SUMMARY

Property Location: 4308 N. Orange Blossom Trl. (west side of N. Orange Blossom Trl., between Ace Rd. and Lakebreeze Dr.) (Parcel #09-22-29-0000-00-038; ±2.09 acres, District 3).

Applicant's Request: The applicant proposes to plat a vacant commercial property as part of an effort to construct a bottled gas, construction and welding supply retailing business. The property is located in the Princeton/Silver Star neighborhood.

Updated: March 24, 2015

DEVELOPMENT PLAN (PER LDC2015-00055)

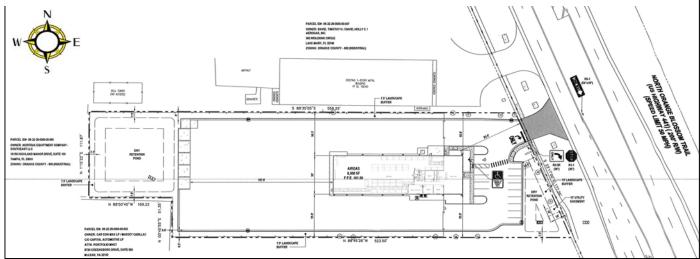
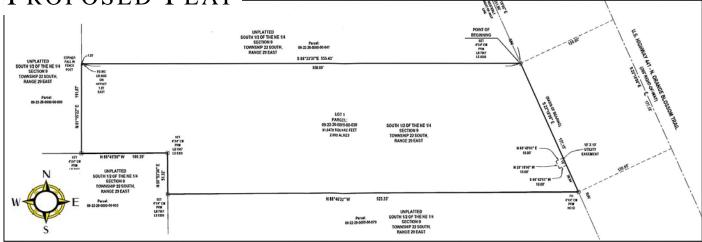
Cross-Access Easement(s) - Sections 61.108 - 61.113 of the Orlando Land Development Code (LDC) requires that parcels provide cross-access easements to adjacent properties at time of development to ensure that parking, access, and circulation may be easily connected to create a unified off-road system.

If a specific location and size for the cross access is identified, the width shall be no less than 24 ft. Cross access easements may be created by depiction on the plat or by a separate recorded instrument. However, if the latter method is used, reference to the recorded document shall be included on the plat.

For the subject property, the easement shall align with the north/south drive aisle on the east end of the property and provide access to the parcels to the immediate north and south.
